Model: Apollon-C1		Date: 21-Aug-06	No.: MB222001
Modified Article: Parts Catalog Correction		Prepared by: K. Hamada	
From: 1st Tech. Support Sec. Service Support Dept.			
Reason for Modification:	☒ Parts catalog correction ☐ Vendor change ☐ Other ☐ To facilitate assembly ☐ To improve reliability ☐ To meet standards ☐ Part standardization ☐ Product Safety ()

Model: Apollon-C1		Date: 15-Sep-06	No.: MB222002
Modified Article: Oil Supply Roller		Prepared by: K. Hamada	
From: 1st Tech. Support Sec. Service Support Dept.			
Reason for Modification:	☐ Parts catalog correction ☐ Vendor change ☐ Other ☐ To facilitate assembly ☒ To improve reliability ☐ To meet standards ☐ Part standardization ☐ Product Safety ()

24.By-pass Feed Section 1 (B222/B224)

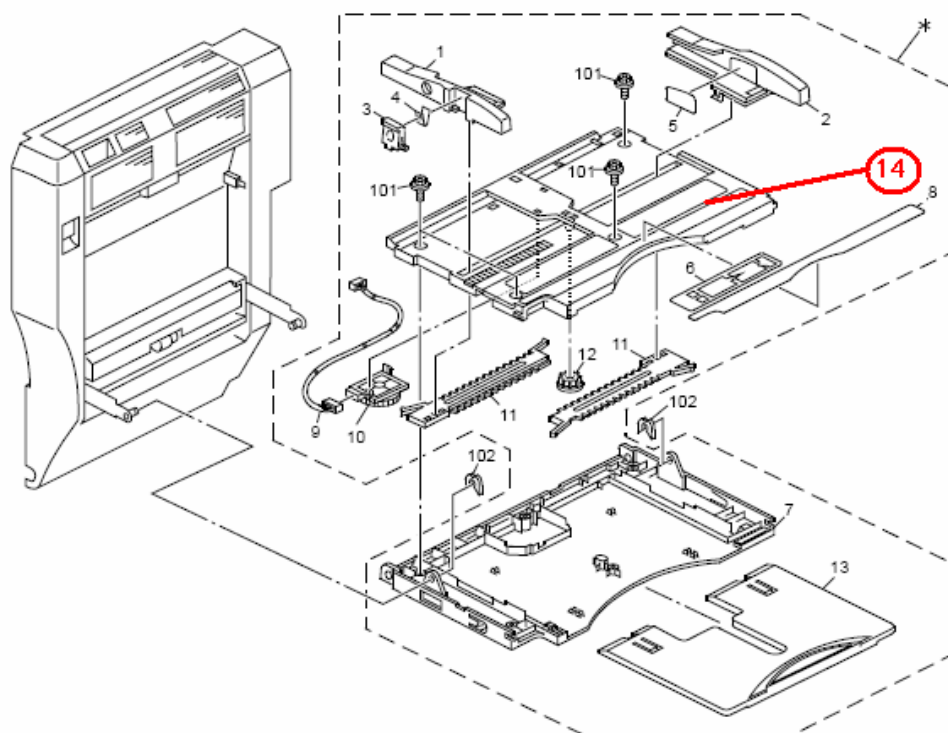
The illustration has added as shown below.

Incorrect part number	Correct part number	Description	Page	Index	Note
B2232662		Manual Feed table	59	*	
	B2232627	Manual Feed Table: Ass'y	59	*

Part number	Description	Page	Incorrect Index	Correct Index	Note
B2232662	Manual Feed table	59	*	14

Change/Reason: The part number and index in the tables were corrected.

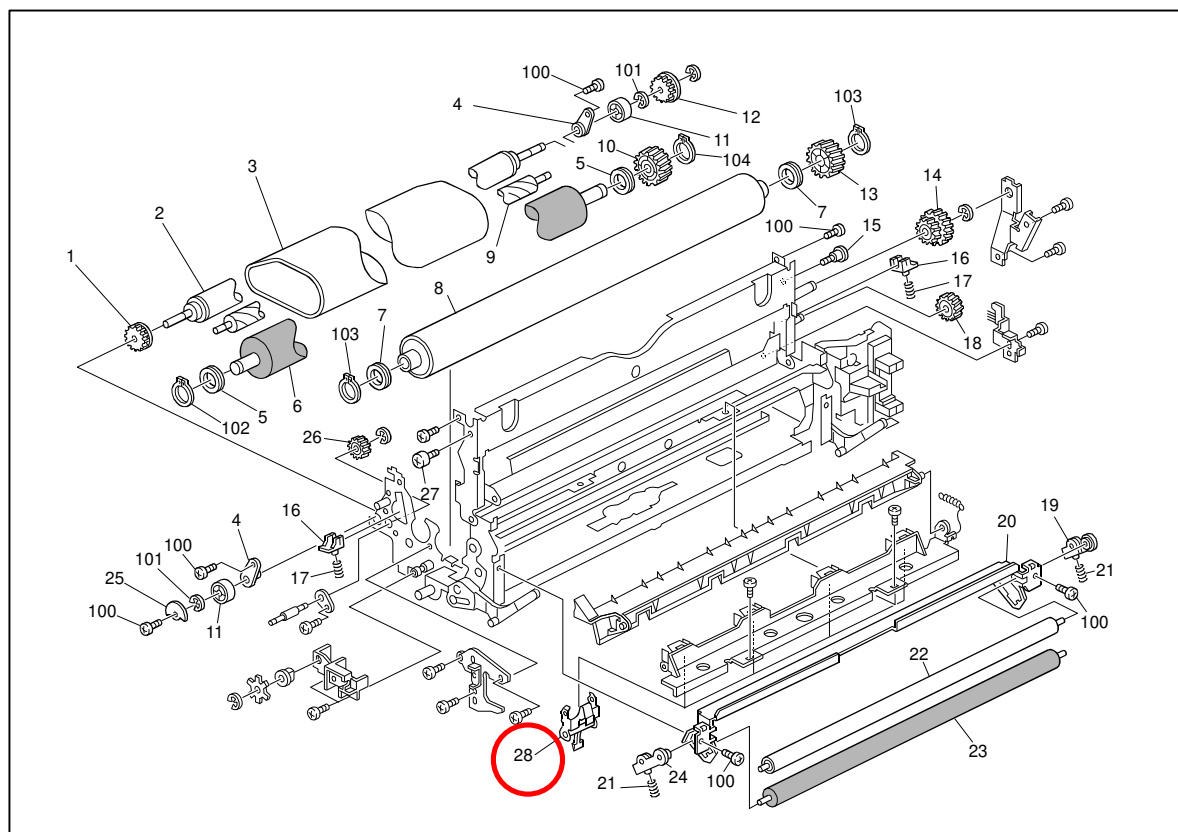
New part number	Description	Q'ty	Int	Page	Index	Note
B2234266	HOLDER: PICKOFF PAWL: ASS'Y	4		71	28

The part number and index in the tables were corrected.

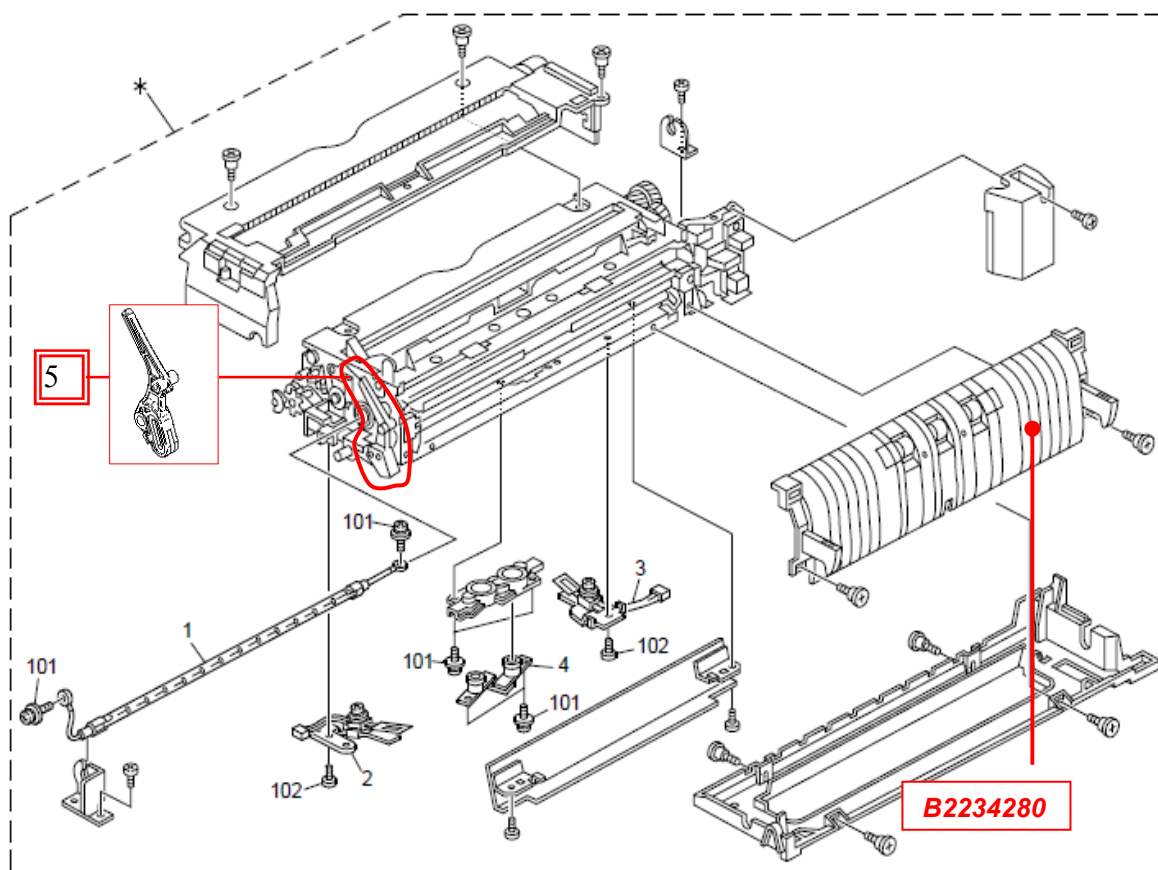
Note: The parts number B2234117 is corrected to ***B2234110***.

Old part number	New part number	Description	Q'ty	Page	Index	Note
	B2234280	FUSING COVER:GUIDE:DUPLEX	1	69		*
	B2234117	LEVER: RELEASE	4	69	5	<i>Incorrect PN</i>
	<i>B2234110</i>	<i>LEVER: FRONT:ASS'Y</i>	<i>1</i>	<i>69</i>	<i>5</i>	<i>Correct PN</i>

Change/Reason: This part was missing from the Parts Catalog.

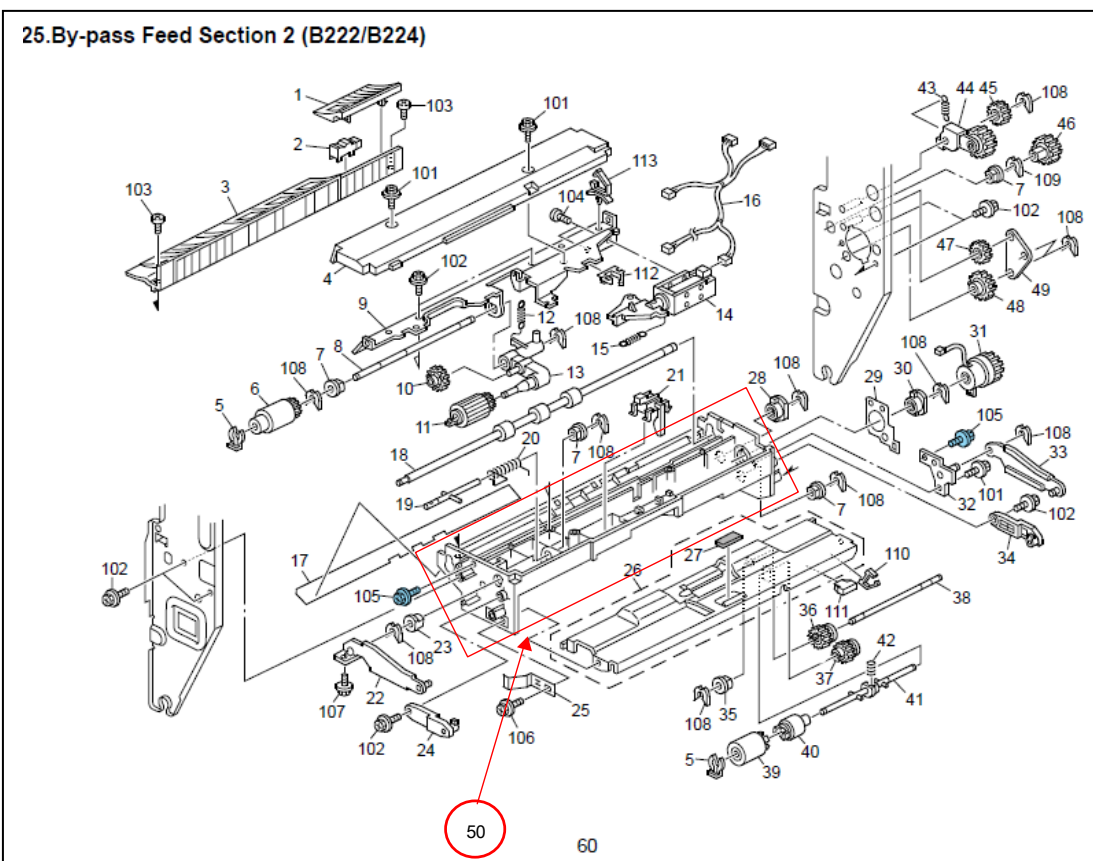
New part number	Description	Q'ty	Int	Page	Index	Note
B2232620	HOUSING: MANUAL FEED	1		60	50

The part number and index in the tables were corrected.

30.Fusing unit 2 (B222/B224)

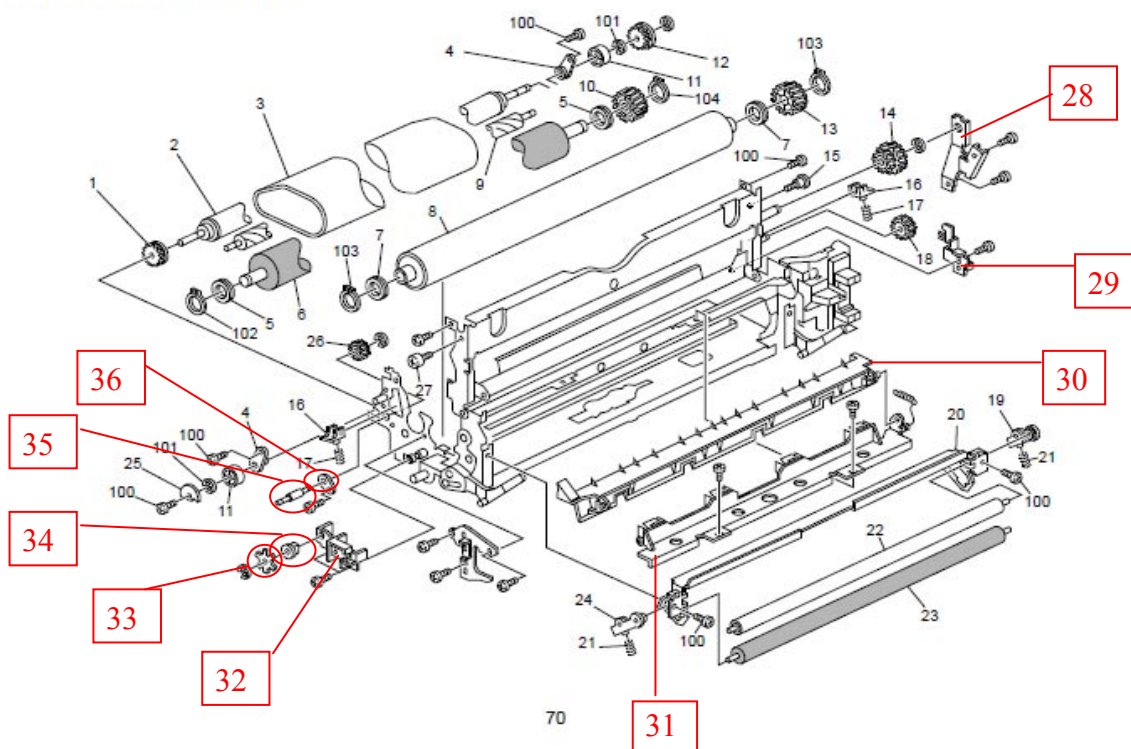
Old part number	New part number	Description	Q'ty	Int	Page	Index	Note
	B2234071	Reinforcing plate: Driving part	1-1		70	28	
	B2234191	Neutralization brush: Heating roller	1-1		70	29	
	B2234276	Guide plate ; Fusing unit exit	1-1		70	30	
	<i>B2234262</i>	Stay ; decoupling click				31	
	B2234143	Terminal block ; Front	1-1		70	32	
	B2234141	Encoder ; Sencor ; Rolling	1-1		70	33	
	AE031066	Sliding axis tray ; Sencor	1-1		70	34	
	AA145289	Axis ; Rolling ; Sencor	1-1		70	35	
	AE031049	Sliding axis tray ; Sencor	1-1		70	36

Change: These parts were added.

Reason: Requests were received from the field.

40.Electrical Section 2 (B222/B224)

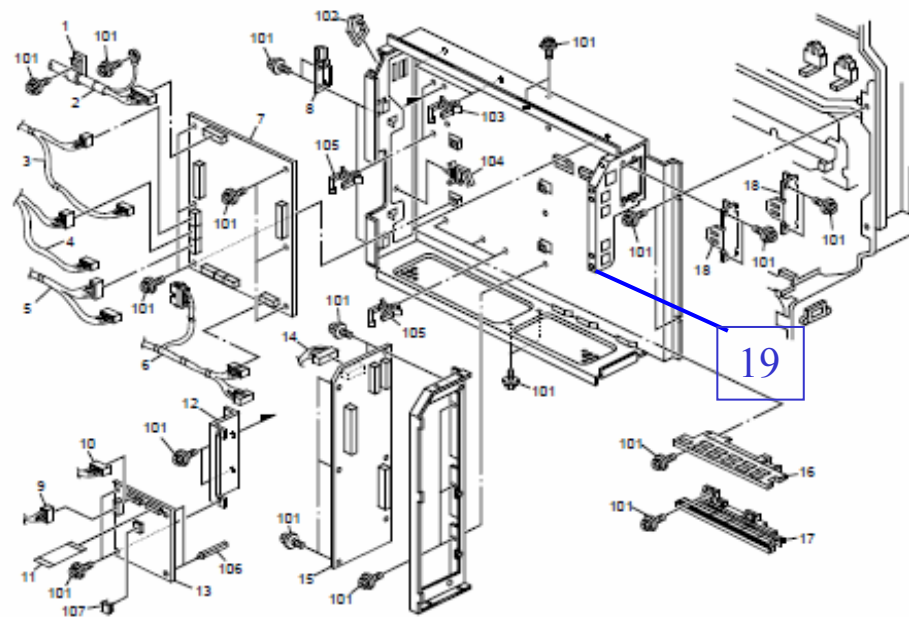
Old part number	New part number	Description	Q'ty	Page	Index	Note
	B2235803	RACK: BACK: ASSIST: LEFT	1	90	19

Change/Reason: This part was missing from the Parts Catalog.

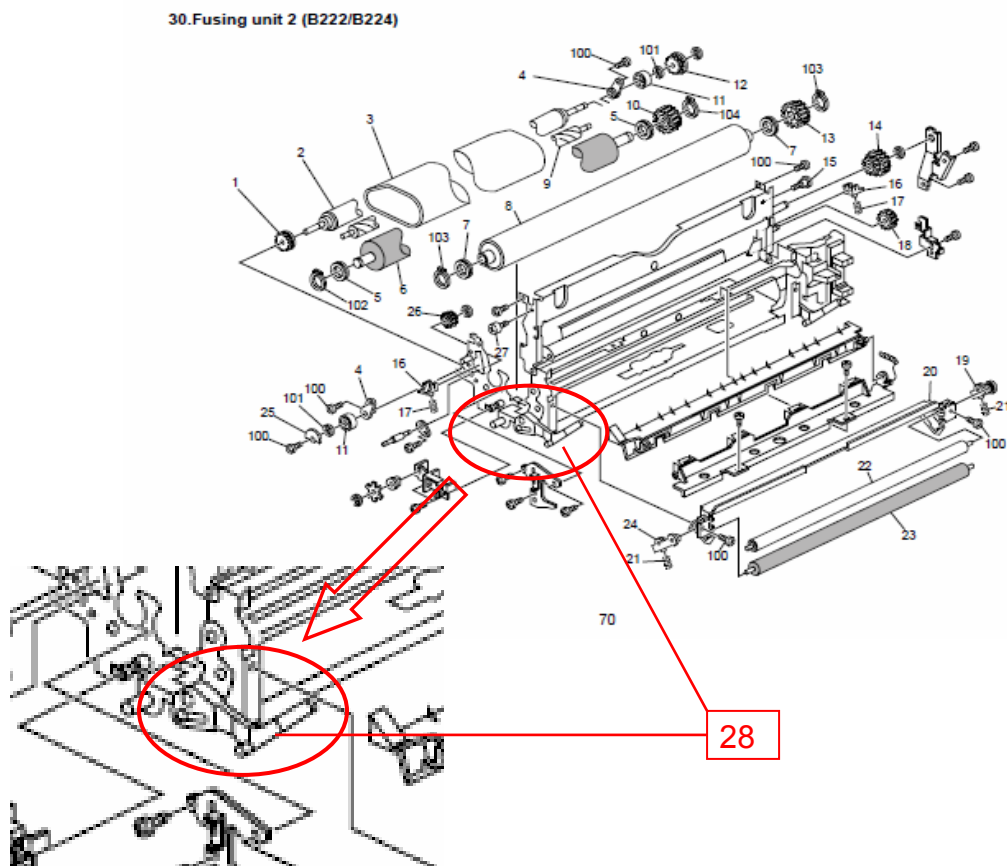
Old part number	New part number	Description	Q'ty	Page	Index	Note
	B2234117	LEVER: RELEASE	1	70	28

Change: This part was added.

Reason: Requests were received from the field.

30.Fusing unit 2 (B222/B224)

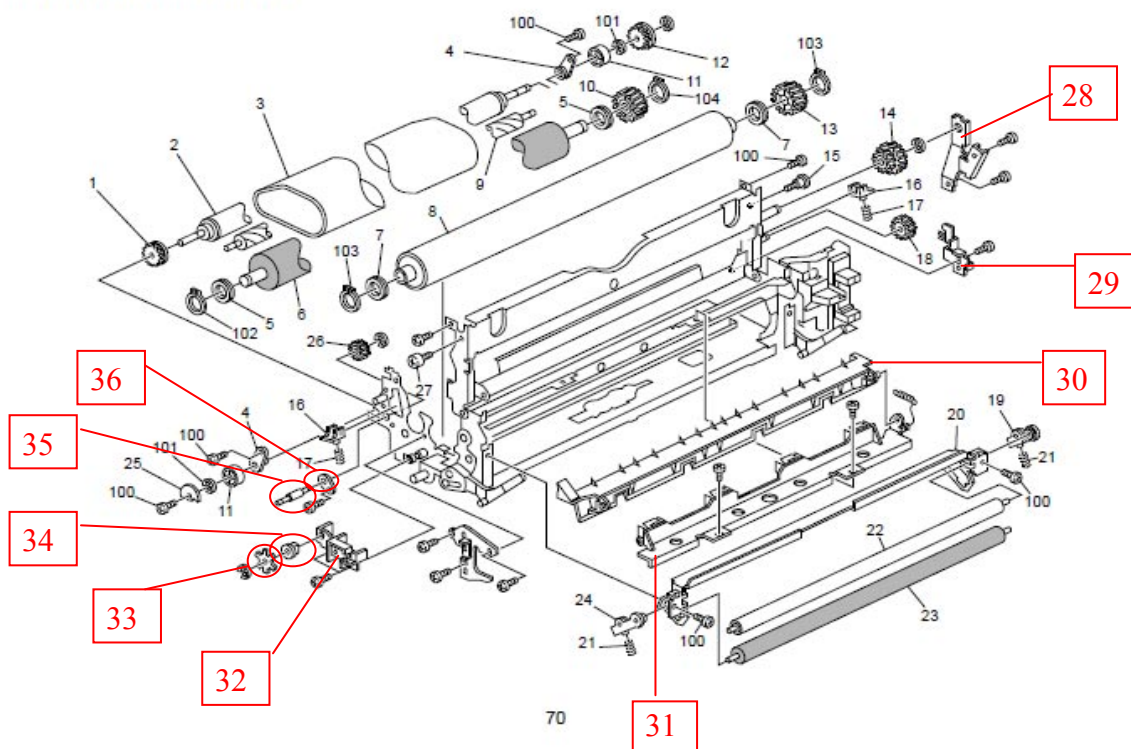
Old part number	New part number	Description	Q'ty	Int	Page	Index	Note
	B2234071	Reinforcing plate: Driving part	1-1		70	28	
	B2234191	Neutralization brush: Heating roller	1-1		70	29	
	B2234276	Guide plate ; Fusing unit exit	1-1		70	30	
	B2234262	Stay ; decoupling click				31	
	B2234143	Terminal block ; Front	1-1		70	32	
	B2234141	Encoder ; Sencor ; Rolling	1-1		70	33	
	AE031066	Sliding axis tray ; Sencor	1-1		70	34	
	AA145289	Axis ; Rolling ; Sencor	1-1		70	35	
	AE031049	Sliding axis tray ; Sencor	1-1		70	36

Change: These parts were added.

Reason: Requests were received from the field.

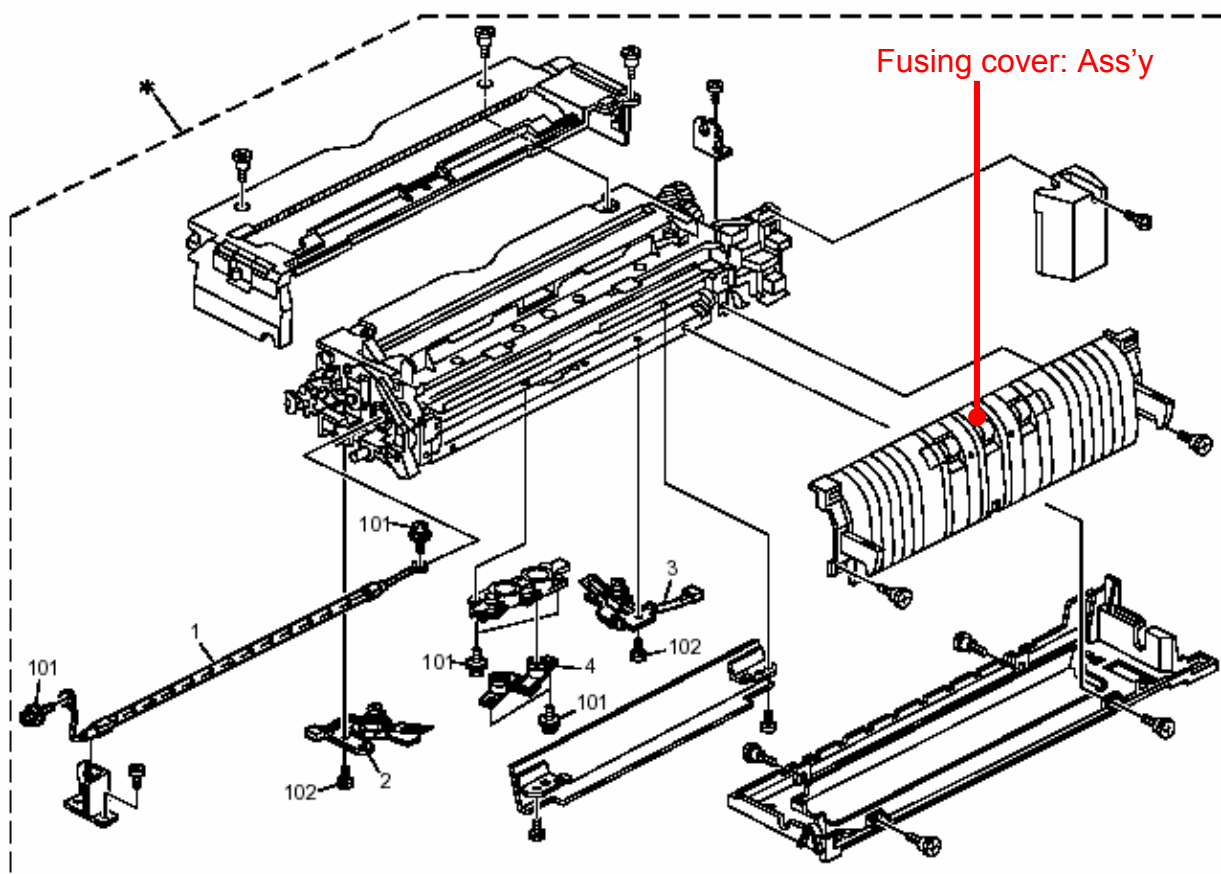
Added part number	Description	Q'ty	Int	Page	Index	Note
B2234280	FUSING COVER: ASS'Y	1		68	*

Change/Reason: The part number is missing.

4.Operation Panel (B222/B224)

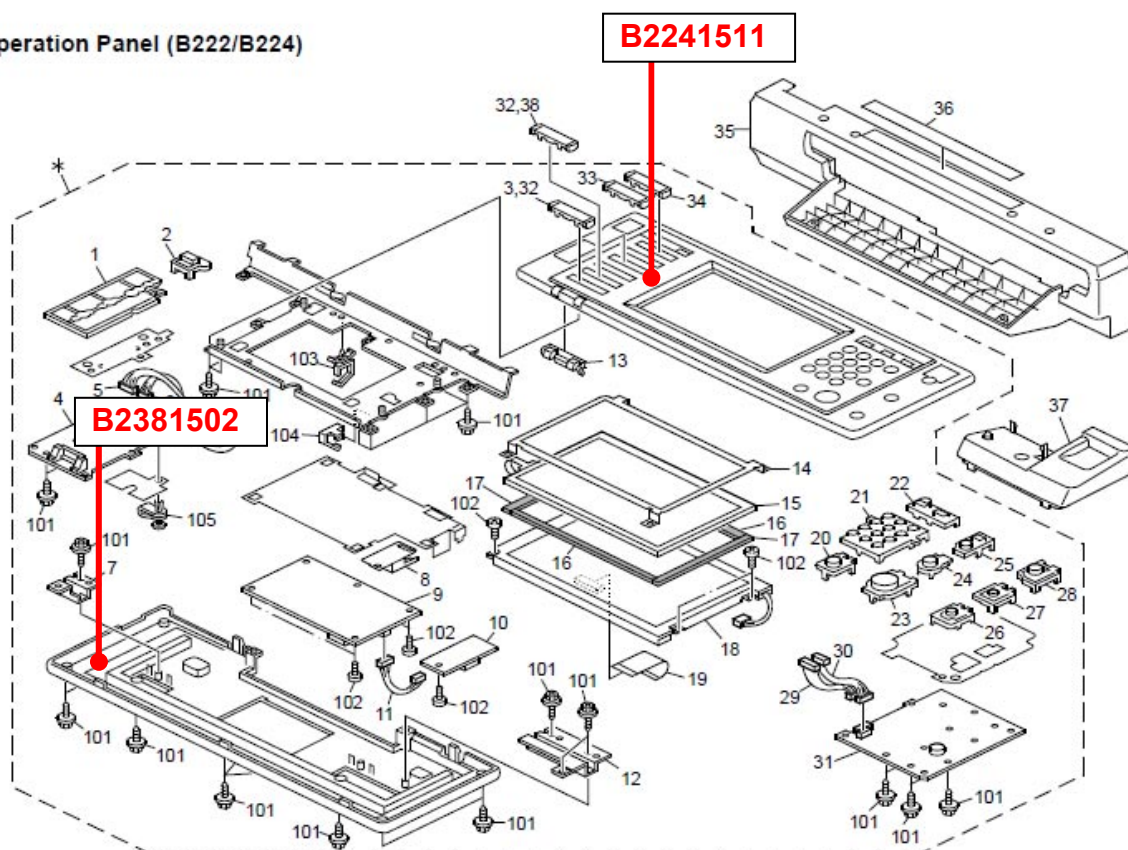
Added part number	Description	Q'ty	Int	Page	Index	Note
B2241511	COVER:UPPER:NA:ASS'Y	1		18		
B2381502	COVER:LOWER	1		18

NOTE: These parts are added as service parts.

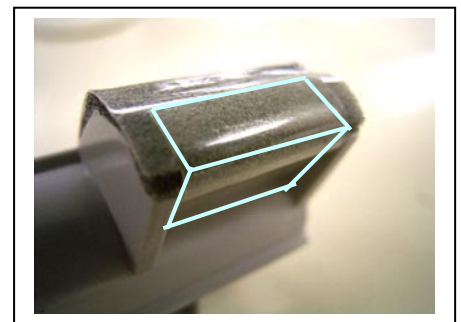
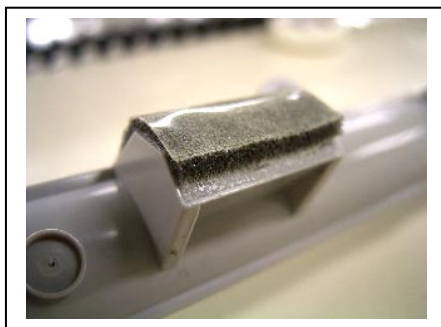
Change: The tape shown in the photo was added.

Reason: To further ensure that the pipe seal does not peel.

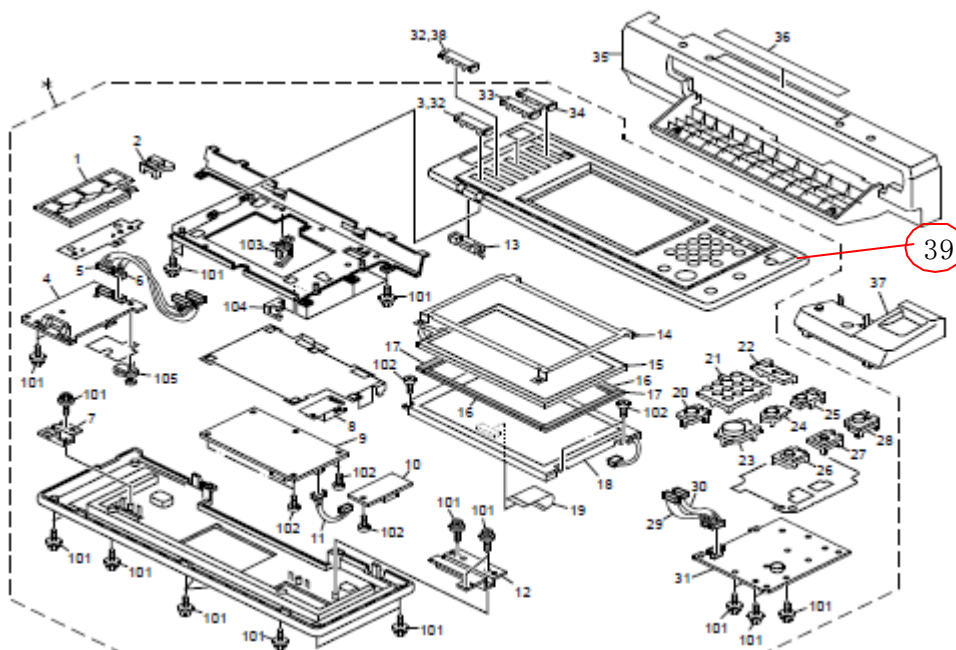
Old part number	New part number	Description	Q'ty	Int	Page	Index	Note
	B2241510	COVER:UPPER:EU:ASS'Y	1		18	*39	
	<i>B2241511</i>	<i>COVER:UPPER:NA:ASS'Y</i>

NOTE: The position to attach the part D0291774: SEAL:GUARD:EXPOSURE GLASS:DOCUMENT FEEDER

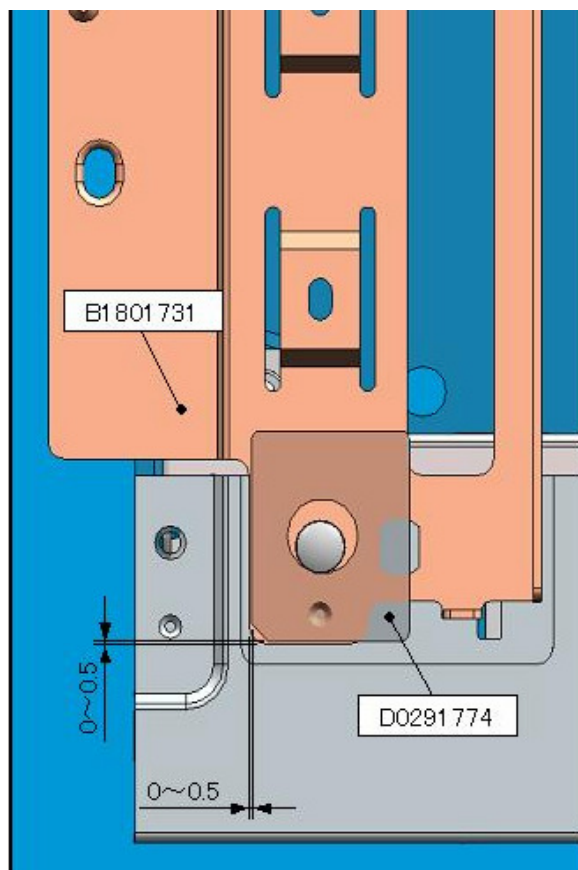
Old part number	New part number	Description	Q'ty	Int	Page	Index	Note
B2231774		SEAL:SHEET THROUGH:DOCUMENT FEEDER			43	5	A
BC012002	D0091782	EXPOSURE GLASS:SHEET THROUGH		O/O	43	4	A
	D0291774	SEAL:GUARD:EXPOSURE GLASS:DOCUMENT FEEDER					A

Important: When you install any of the parts labeled "A" in the table for the first time, make sure to install them **together as a set**.
